A320/A321

SERVICE BULLETIN CHANGE NOTICE

S.B. No. A320-21-1028 REV. 3
Mod. No. 20752P1057

TITLE : AIR CONDITIONING - COCKPIT CLIMATIZATION THERMAL COMFORT
IMPROVEMENT.

Cockpit Air Distribution Ducting Installation
Figure 1, Sheet 1 of 3

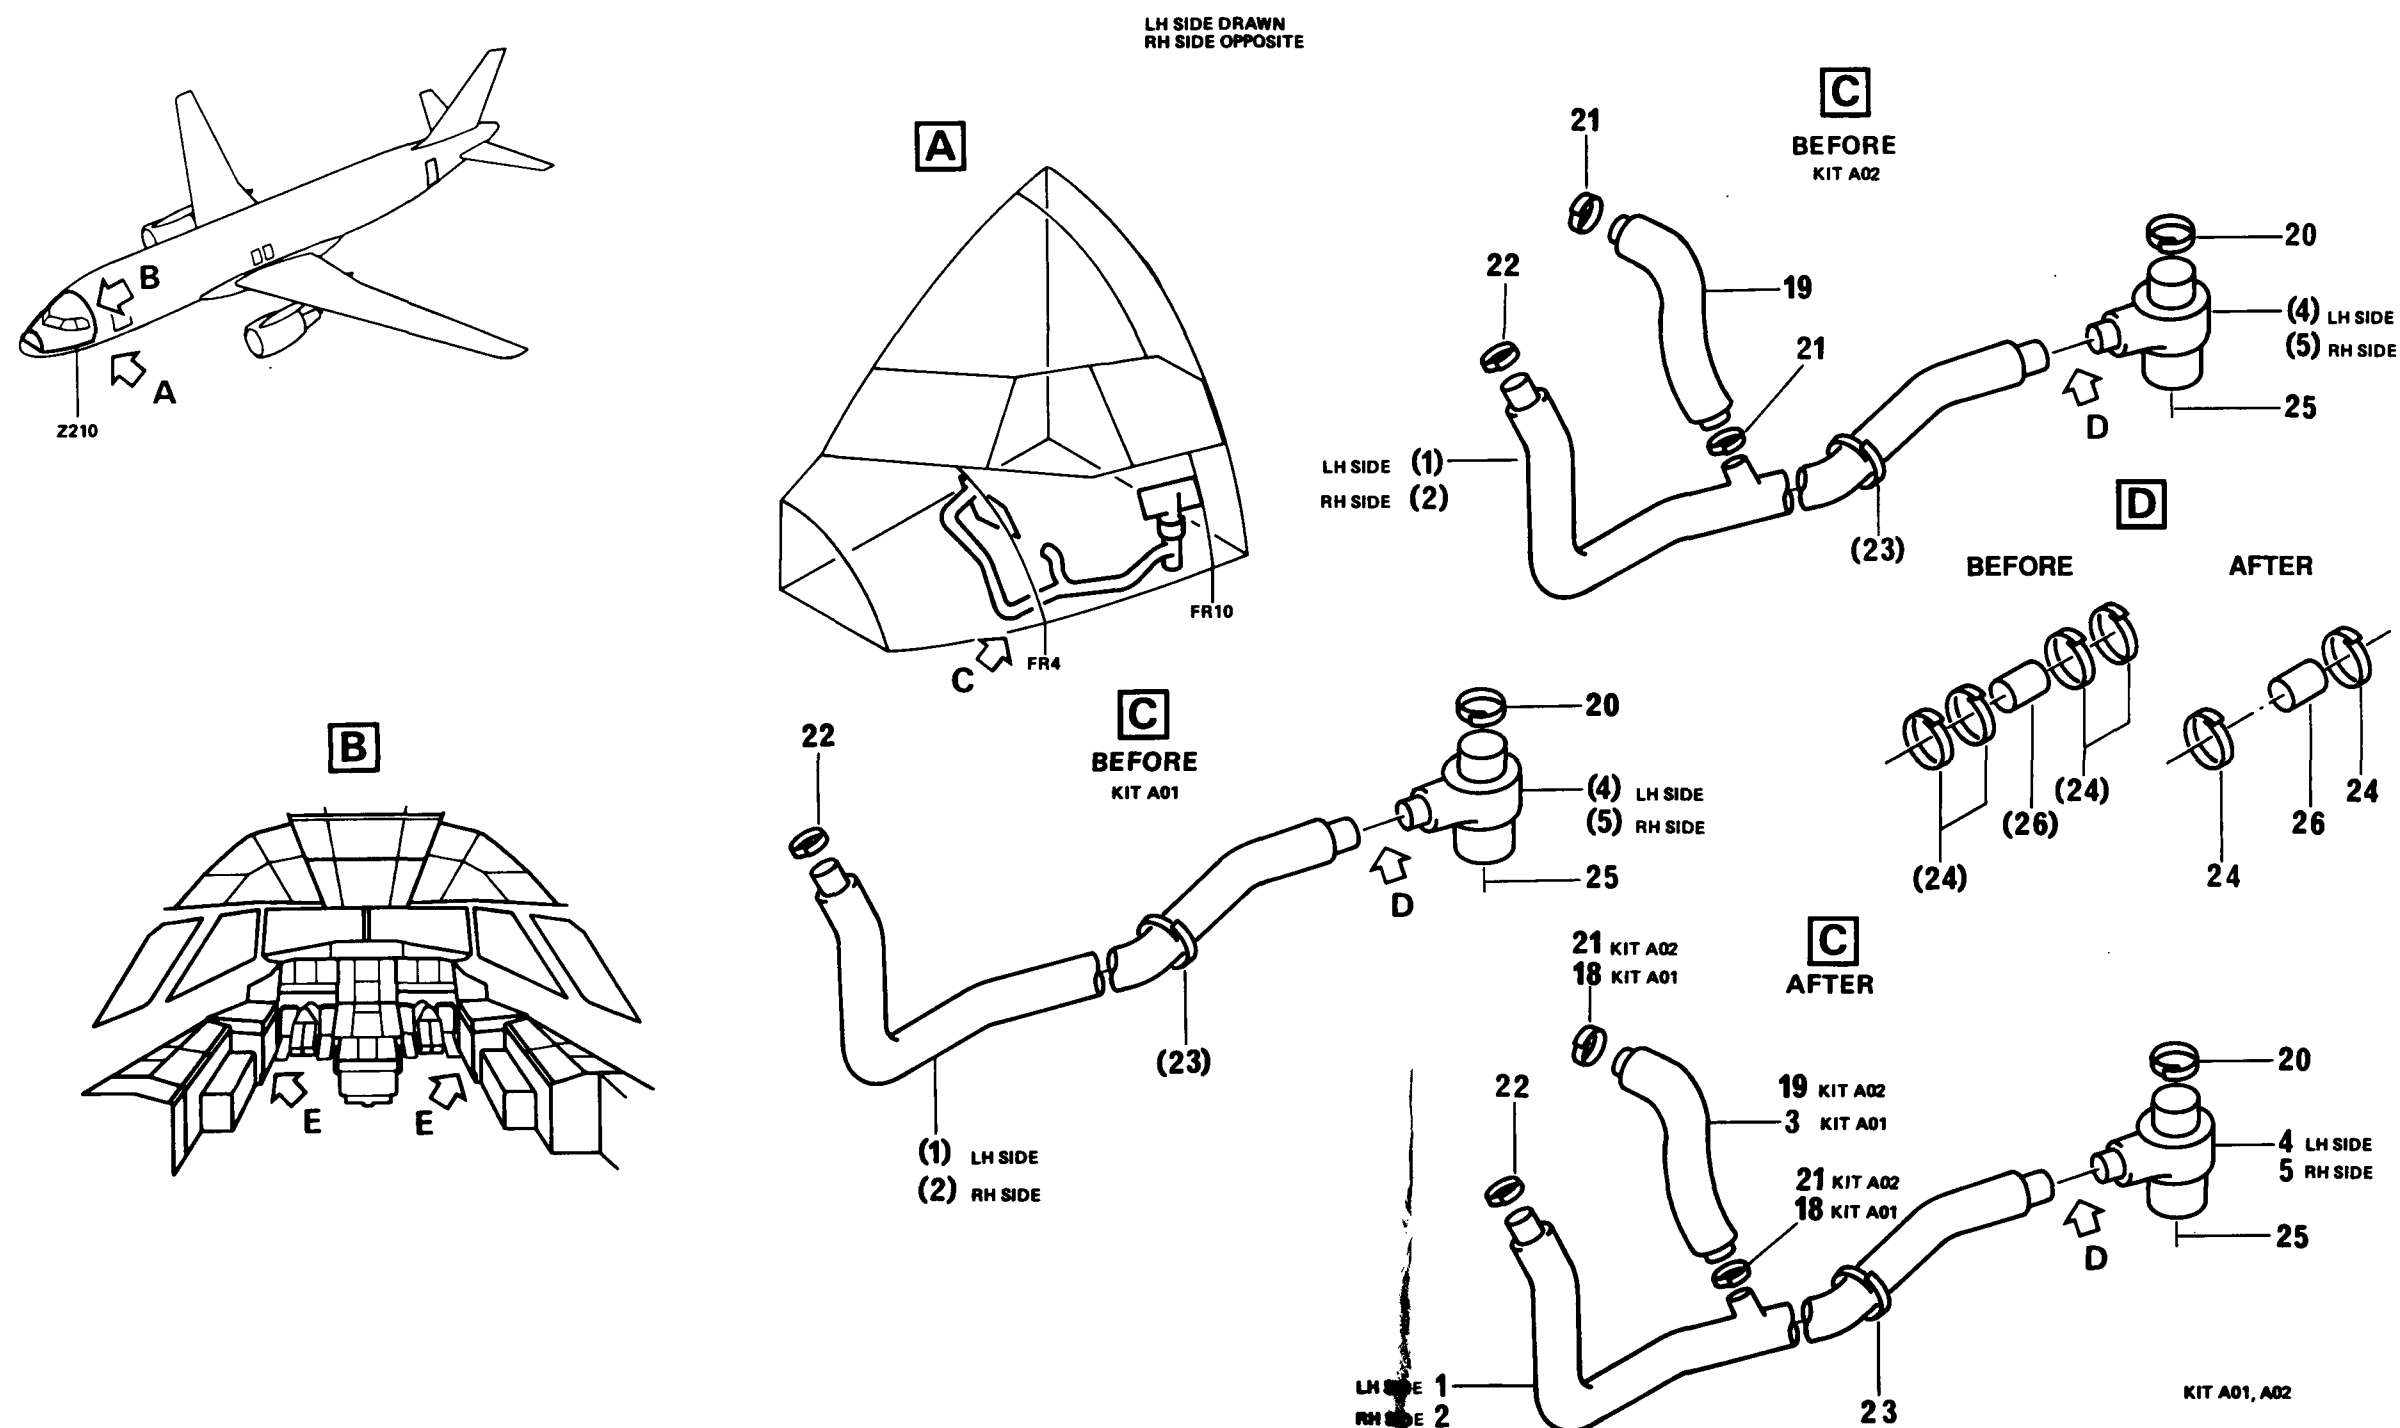
- (1) Remove the duct of the supply system in the flight compartment, zones 211, 212.

1 duct	Item (1) (discard)
1 duct	Item (4) (discard)
1 sleeve	Item (26) (discard)
4 clamps	Item (24) (discard)

(2) Install the new duct of the air conditioning system in the flight compartment and the adjustment system.

1 front web assy	D9251071000400	Item 8
1 adjustment system	D2121109300000	Item 10
12 rivets	ASNA2050DEJ04020	Item 12
5 screws	NAS1096-3-8	Item 13
5 washers	AN960-10L	Item 17
8 screws	NAS1102-06-6	Item 14
8 nuts	MS21042-06	Item 15
8 washers	AN960-6L	Item 16
1 duct	D2121052700400	Item 4
1 duct	D2121108000040	Item 1
1 duct	D2101001722740	Item 3
1 side panel assy	D2511120500400	Item 6

Cockpit Air Distribution Ducting Installation
Figure 1, Sheet 2

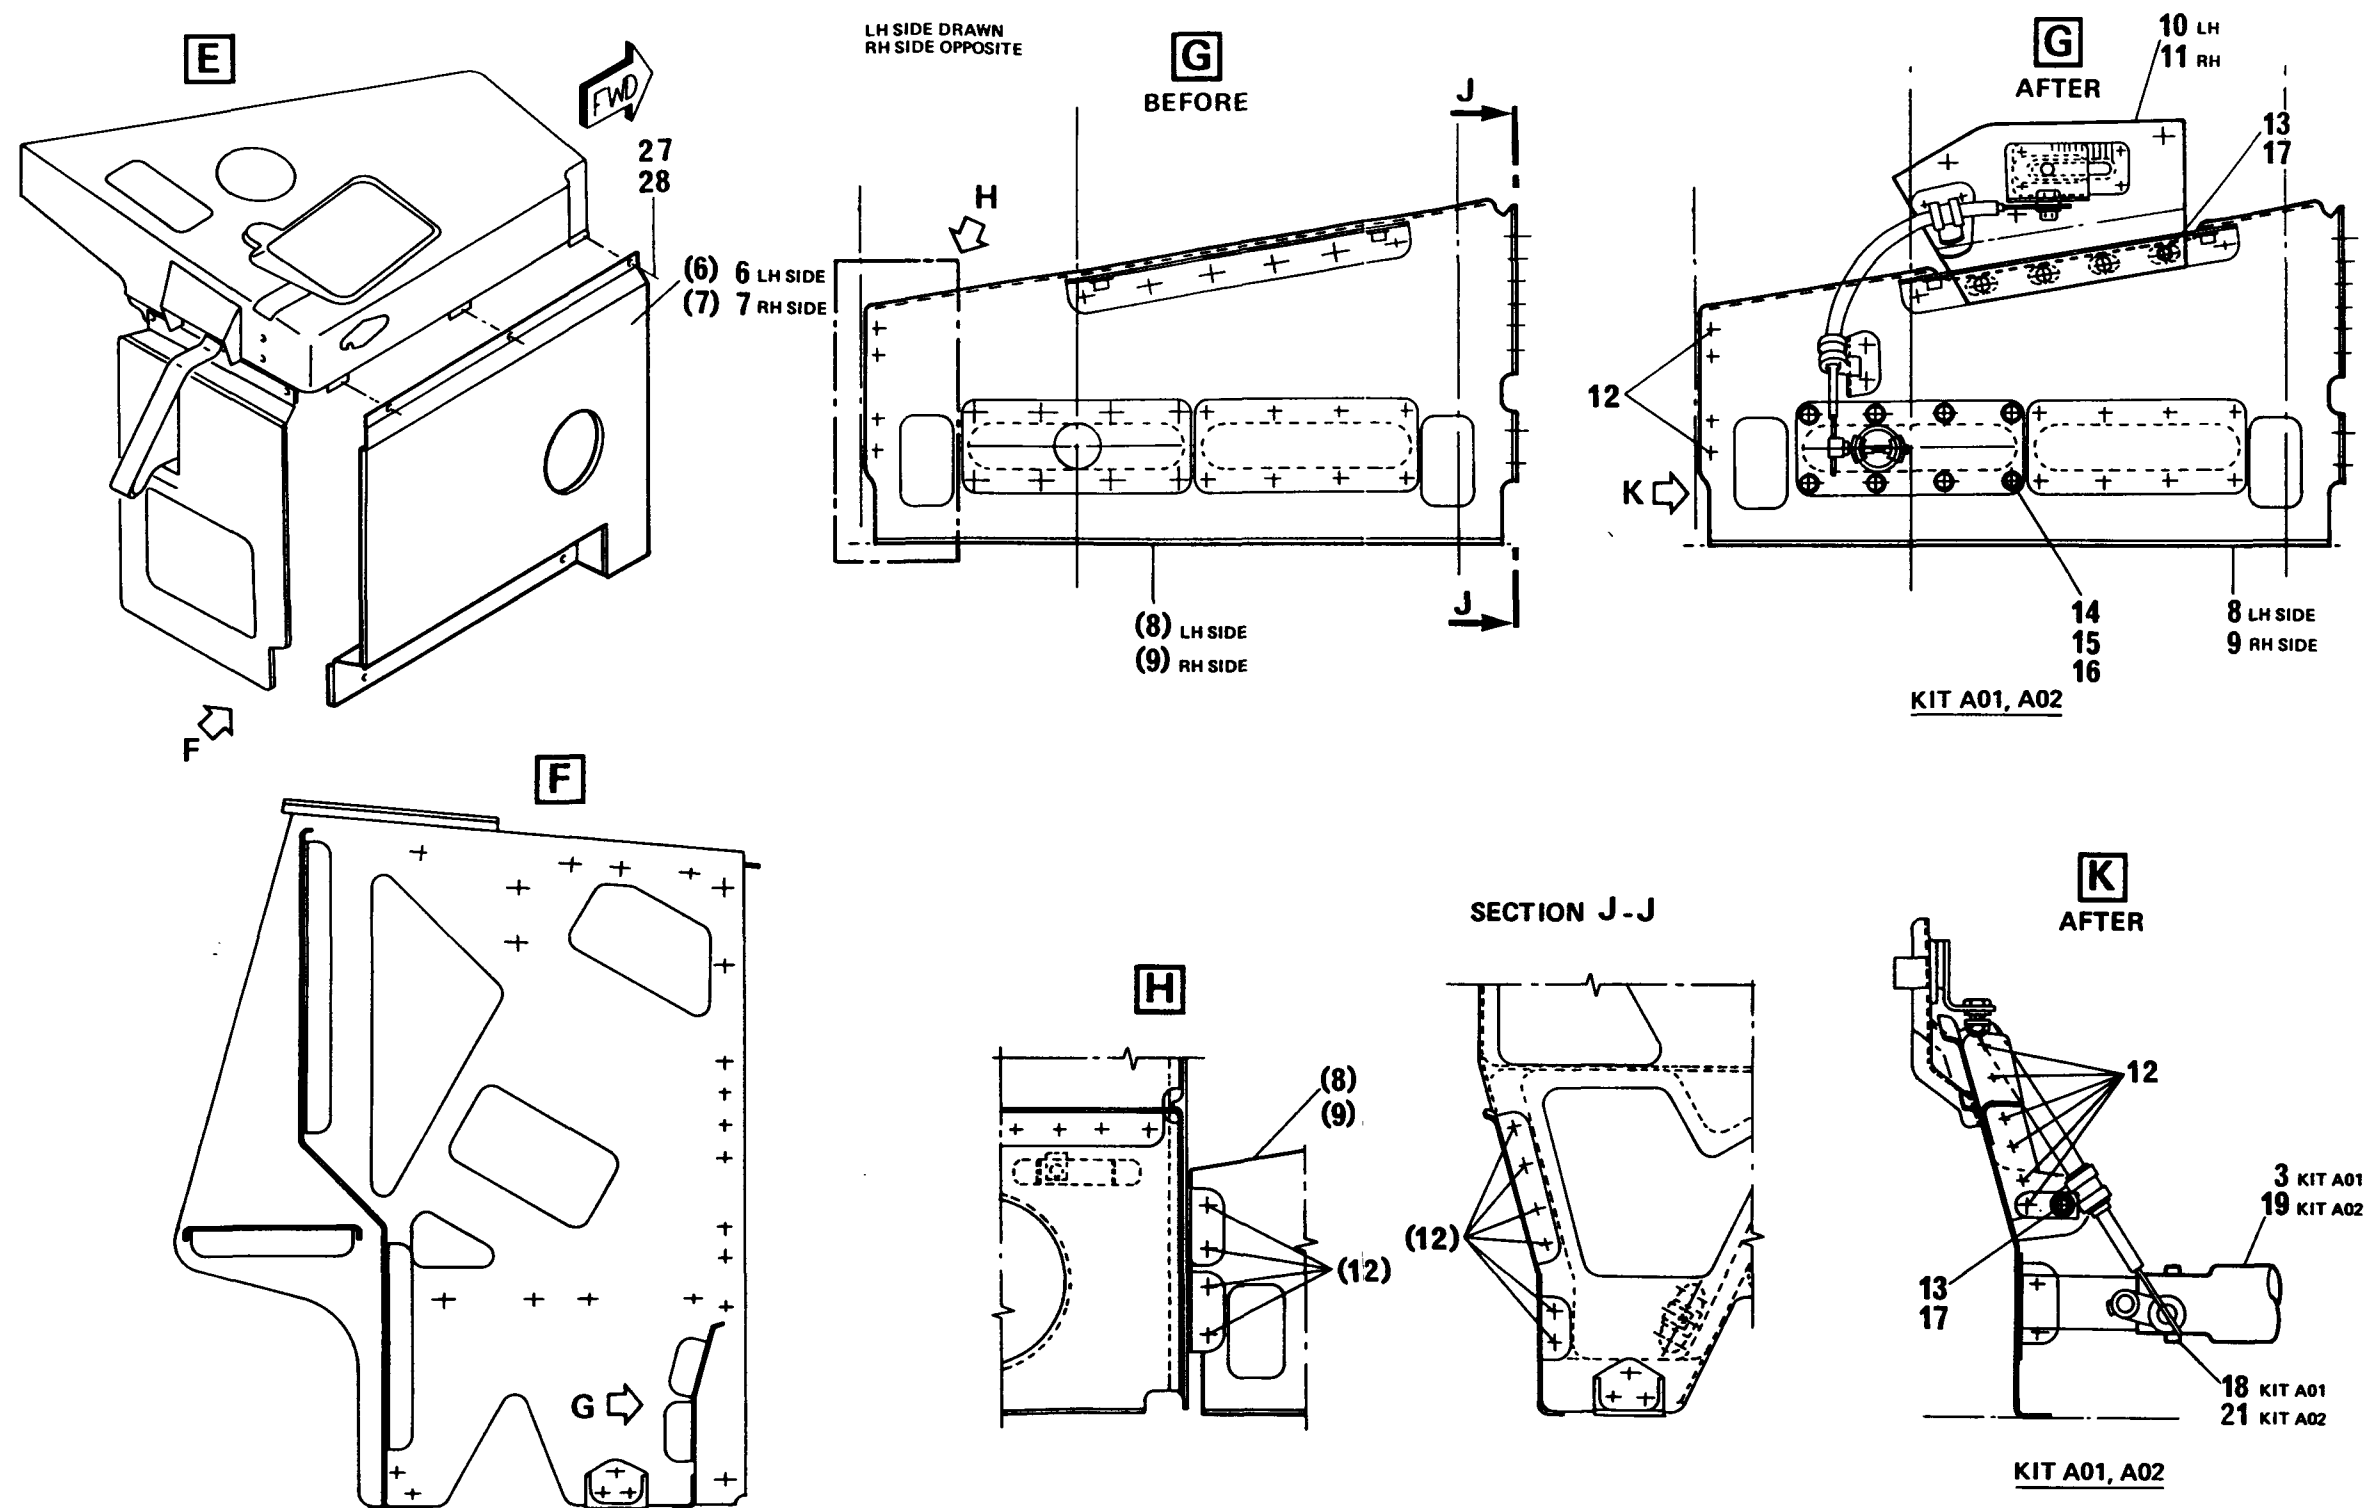
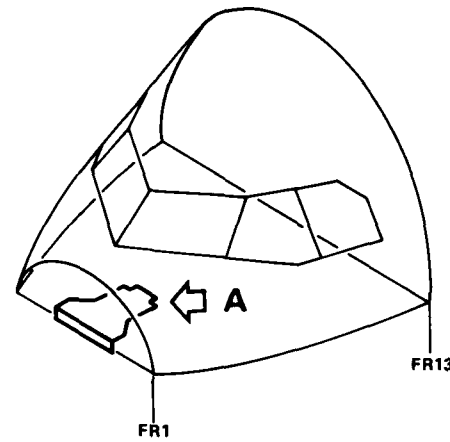
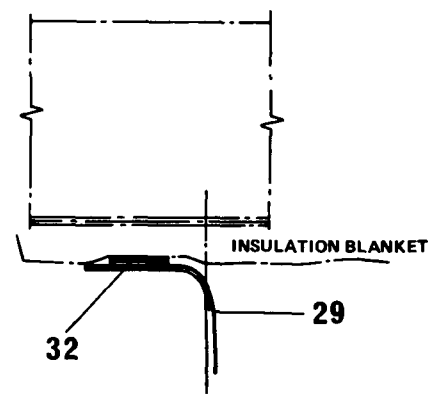
Page 5 - Para. 2.B.(1)(a), Items 24 and 26 becomes discard.
Page 6 - Items 23, 24 and 26 becomes discard.
Page 7 - Items 23, 24 and 26 part number modified.
Page 8 - Items 23, 24 and 26 becomes discard.
Page 9 - Item 23 (retain) become (discard).
- Items 23, 24 and 26 part number modified.
Page 10 - Items 23, 24 and 26 part number modified.
Page 13-14 - Figure 1, Sheet 1 of 3 modified.
Page 19 - Kit A01, addition of Items 23, 24 and 26.
Page 20 - Kit A02, addition of Items 23, 24 and 26.

Material-Panel Assy Installation
Figure 1, Sheet 3

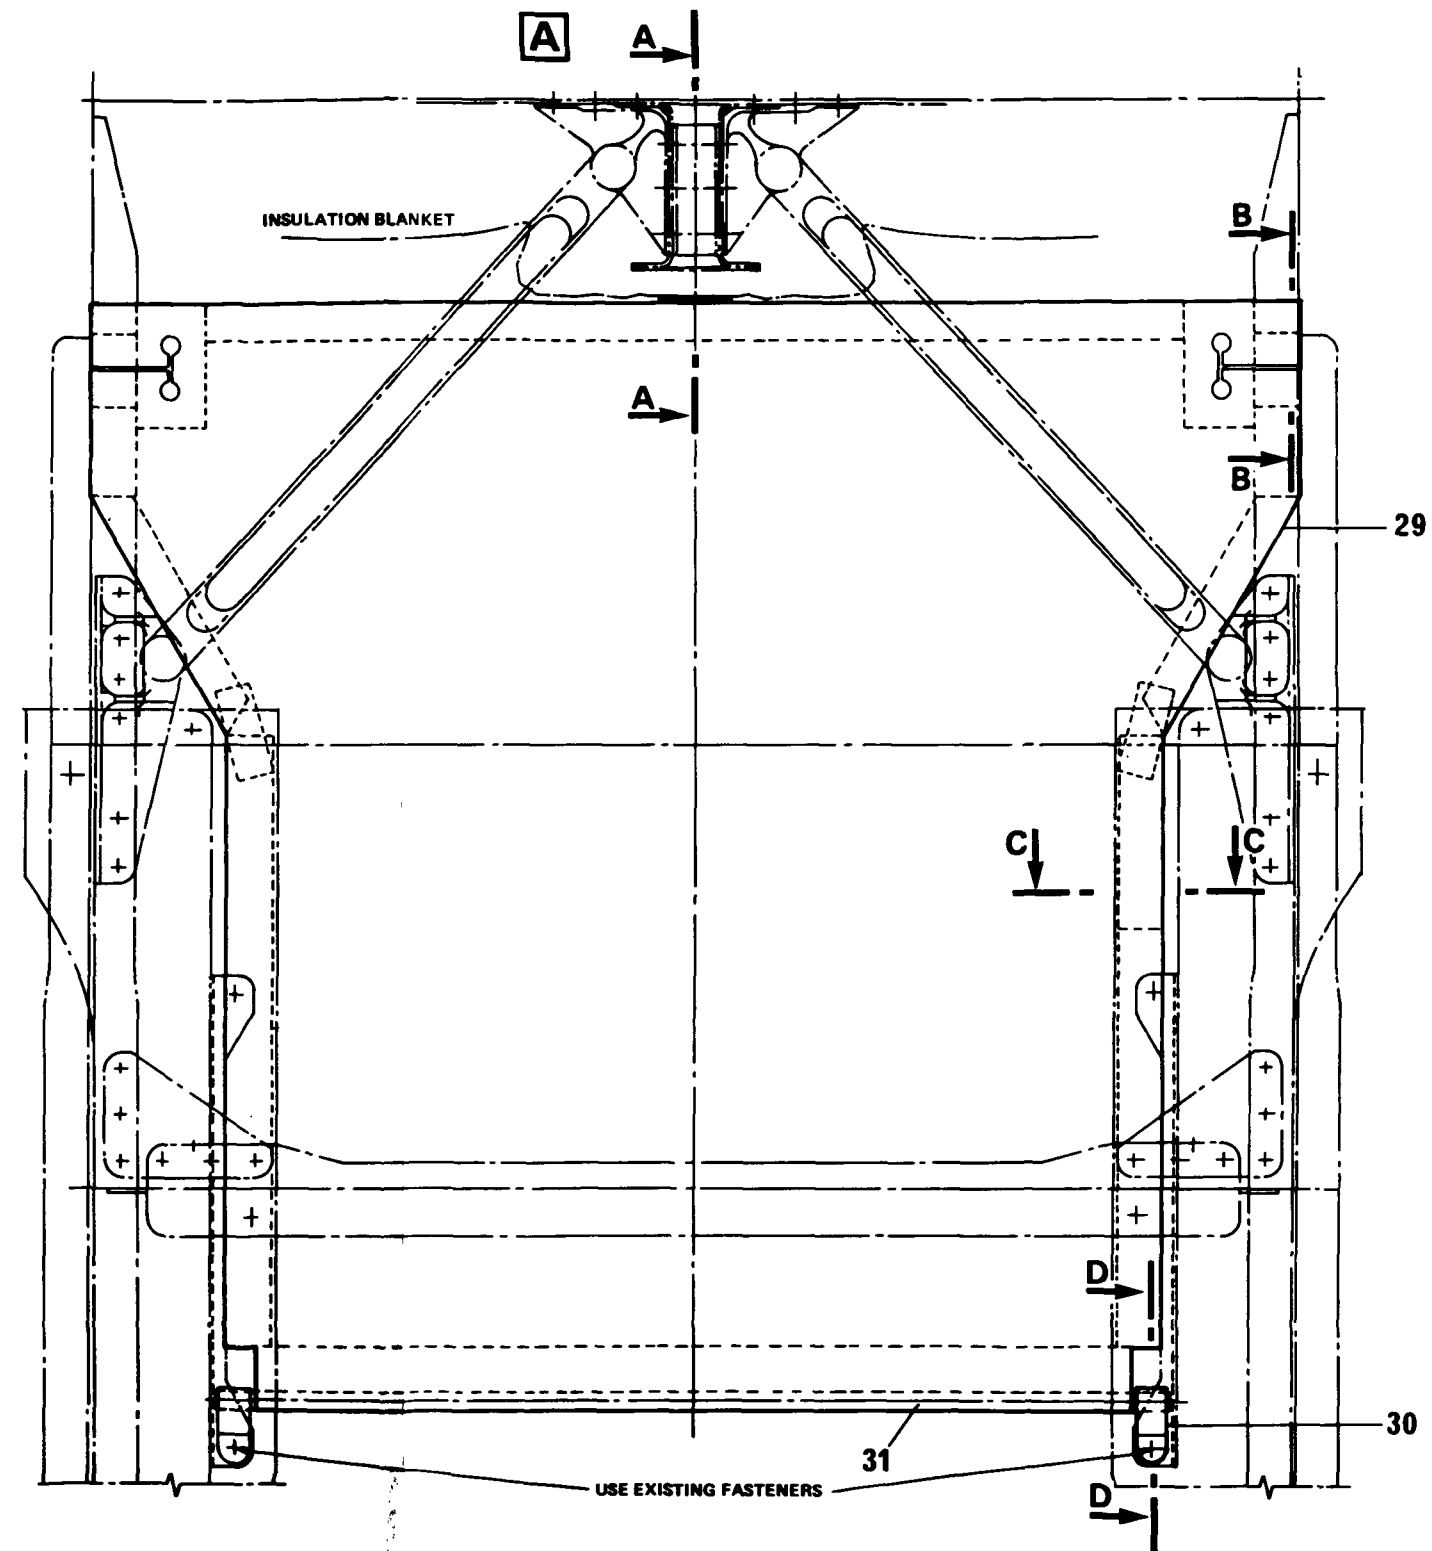
1 material-panel assy	D2121109900000	Item 29
2 clamps	D2121109720000	Item 30
1 hinge	D2121109820000	Item 31
3 bande velcro	D2581008120100	Item 32
2 bande velcro	D2581008120300	Item 33

NOTE: ITEMS 32 AND 33
TO BE BONDED AT ASSEMBLY
